AERONAUTICAL CHARTING FORUM
Instrument Procedures Group
October 23, 2012

FAA Control # 12-02-305

Subject: Conflict Between STAR VNAV Path and MEA

EAGUL FIVE ARRIVAL (RNAV) Arrival Routes

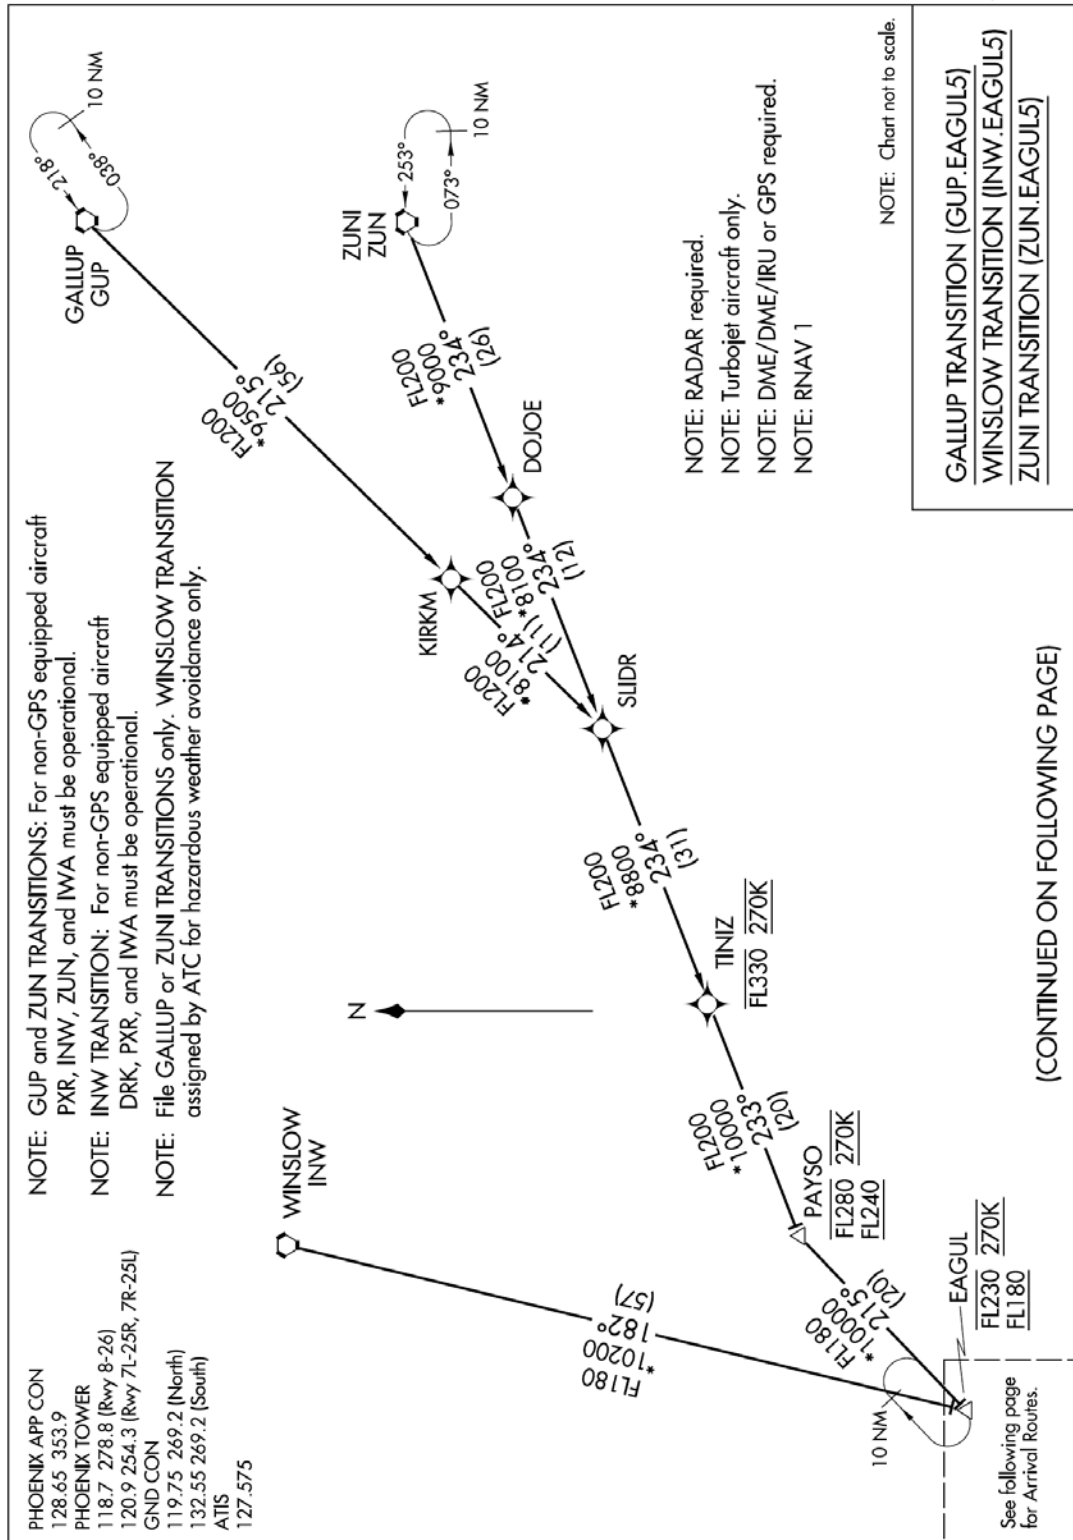
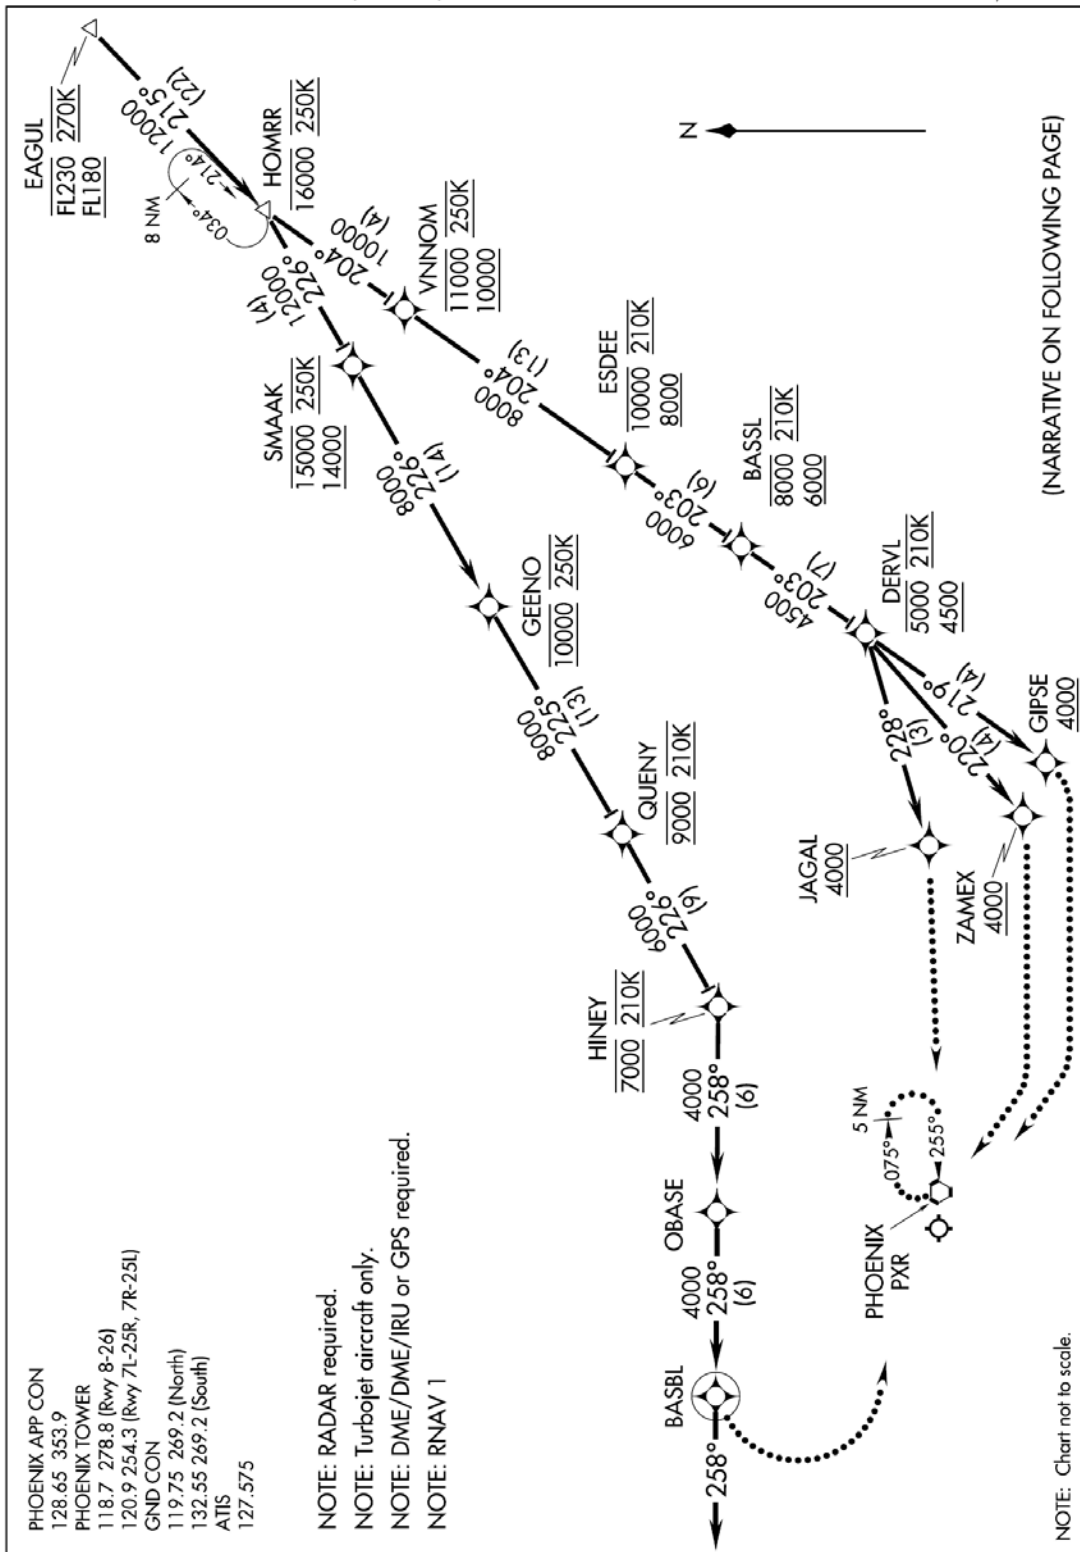
Background/Discussion: It was brought to the attention of the AA Safety Action Program (ASAP) team at Allied Pilots Association (APA) that a potential disconnect between the procedure's VNAV path and the MEA segment at that point exist on the EAGUL5 STAR at Phoenix Sky Harbor Int'l (KPHX). If the FMS or crew uses the bottom limit of the VNNOM waypoint (10000 ft) to make speed requests by ATC or handle a tailwind, the FMS calculated VNAV path, in some cases, will descend below the published MEA (12000 ft) on the segment between EAGUL and HOMRR (only 4.1 nm from VNNOM). The primary problem appears to be at the fix HOMRR, which only publishes an "At or below 16000" altitude restriction. It is one of the only fixes in a string of fixes that does not set the bottom altitude in the Descend Via route.

Initial Discussion - MEETING 12-02: New recommendation presented by Lev Prichard, APA. Lev expressed concern that FMS coding of the EAGUL STAR at Phoenix causes pilots to violate the MEA on the segment from EAGUL to VNNOM by allowing descent to 10,000 prior to HOMRR, which is below the specified MEA of 12,000. Although the EAGUL STAR is used as an example, Lev, believes that policy should be established to preclude this from occurring. Kevin Allen, US Airways, stated that Flight Standards in the Southwest Region is aware of this problem and is working a fix. Lev recommends, as a short term solution to this specific problem, a NOTAM to specify a bottom altitude of 12,000 at HOMRR. This would make crews aware of the issue and force FMS calculated VNAV paths to stay above the MEA. The NOTAM should be followed up with a revised STAR ASAP. Bill Hammett, AFS-420 (ISI) noted that while there is nothing in the current Order to prevent this, a new Order JO 7100.9E is currently in coordination that should resolve the problem by addition of the following (red text) in paragraph 7a(10)

Brad Rush AJV-3B, stated that the procedure was correct, but the coding was wrong in that it should have accounted for the MEA of 12,000 to HOMRR. Josh Fenwick, AeroNavData, Inc., responded that the coding was according to the NFDD's source, but there was an error on the supporting form. All agree that the proposed text for Order JO 7100.9 will resolve the issue. Kyle McKee, AJV-14, took the IOU to track publication of the revised Order.

Recommendations: As a short term fix to this specific problem, recommendation is to NOTAM a bottom altitude for the fix at HOMRR of 12000 ft causing crews to be aware of the issue and forcing FMS calculated VNAV paths to stay above the MEA. Since STARs may not be permanently be revised via NOTAM, the NOTAM should be followed up expeditiously with an amended STAR so the restriction may be permanently charted and coded. Initial investigation shows that this situation may exist on similar Phoenix area STARS as well as at other airports. There appears to be a procedural design flaw that would allow this to happen, and thus I would encourage the Instrument Procedures Group to task the appropriate office to establish policy to ensure that bottom altitudes are always specified above any established MEAs to prevent this issue on all STARS.

(10) Establish a minimum en route altitude (MEA) for each segment of the STAR. The MEA will be established based upon obstacle clearance over the terrain or manmade obstacles, adequacy of navigation coverage, and communication coverage. Follow the guidance in FAA Order 8260.19, to determine the communication requirements. Conventional, RNAV and RNP STARs follow guidance in FAA 8260 series orders to establish the MEA. At, at or above, and block altitudes may be charted to accommodate ATC requirements and profile descents. If possible avoid use of at or below altitudes. **All altitudes must be at or above the established MEA.** The termination altitude for STARs attached to an SIAP IAF, IF or Final Approach Course Fix (FACF) must coincide with the fix altitude published on the SIAP. For RNAV and RNP STARs, evaluate the Obstacle Evaluation Area (OEA) for feeder routes.

MEETING 13-01: Jim Arrighi, AJV-14, briefed that the recommended verbiage (See previous meeting minutes) to address the issue has been included in the draft FAA Order JO 7100.9, which is targeted for publication December 13, 2013. The issue remains open pending publication. **ACTION: AJV-14.**

MEETING 13-02: Jim Arrighi, AJV-14, briefed that Order JO 7100.9E was signed on September 27, 2013. **Issue CLOSED.**
